Applicant: Joel Livingood; Interlachen Country Club
Consultant: Lindsey Roberts McKenzie; SEH, Inc.
Project: Interlachen Country Club Golf Course Renovation
Location: 6200 Interlachen Boulevard, Edina, MN
Applicable Rule(s): 2, 3, 4, 5, 6, 10, 11 and 12
Reviewer(s): Louise Heffernan; Barr Engineering Co.

Figure 3. Proposed drainpipe locations (shown in red).

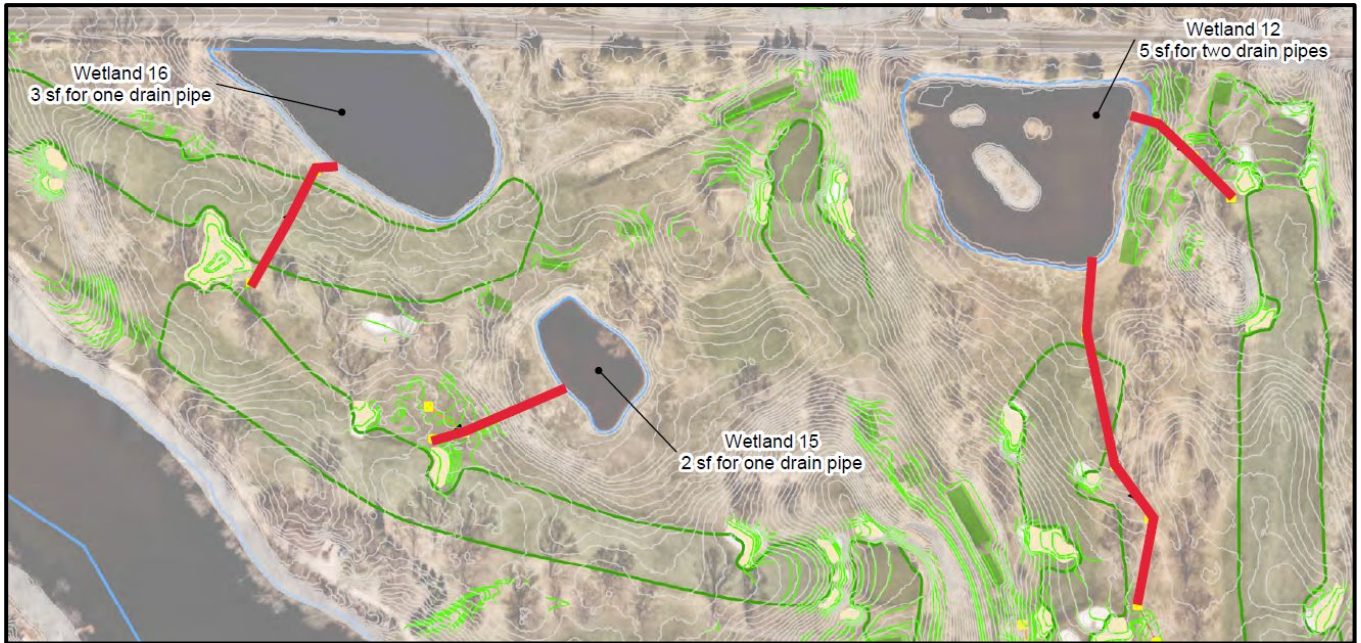
NMCWD's Waterbody Crossings and Structures Rule 6.0 applies to the project because drainpipe is proposed to be installed within the beds or banks of Wetlands 12, 15 and 16. The locations of the proposed drainpipe are shown in red on Figure 3 below.

New 6-inch and 12-inch drainpipe is proposed to be installed in the bank or bed of Wetlands 12, 15 and 16 for the purpose of conveying stormwater runoff from depressions within the wetlands' drainage area boundaries.

Because impervious areas are not proposed to be increased within the site, subwatershed drainage areas or boundaries are not to be altered, an increase in additional stormwater runoff volume will not be generated (impervious area reduced), discharge rates from the site will be maintained and or reduced, and flood storage volume below the 100-year frequency flood elevation for each wetland will be maintained, the engineer finds that the installation of the drainpipes will not result in hydraulic capacity modifications or increases in the flood stage of the wetlands. The materials demonstrate and the engineer finds that the project is in conformance with subsection 6.3.1a criteria.

The applicant has demonstrated and the engineer finds that the proposed drainpipe configuration represents the minimal impact solution, based on evaluation of the alternative designs. The project is in conformance with subsection 6.3.1e criteria.
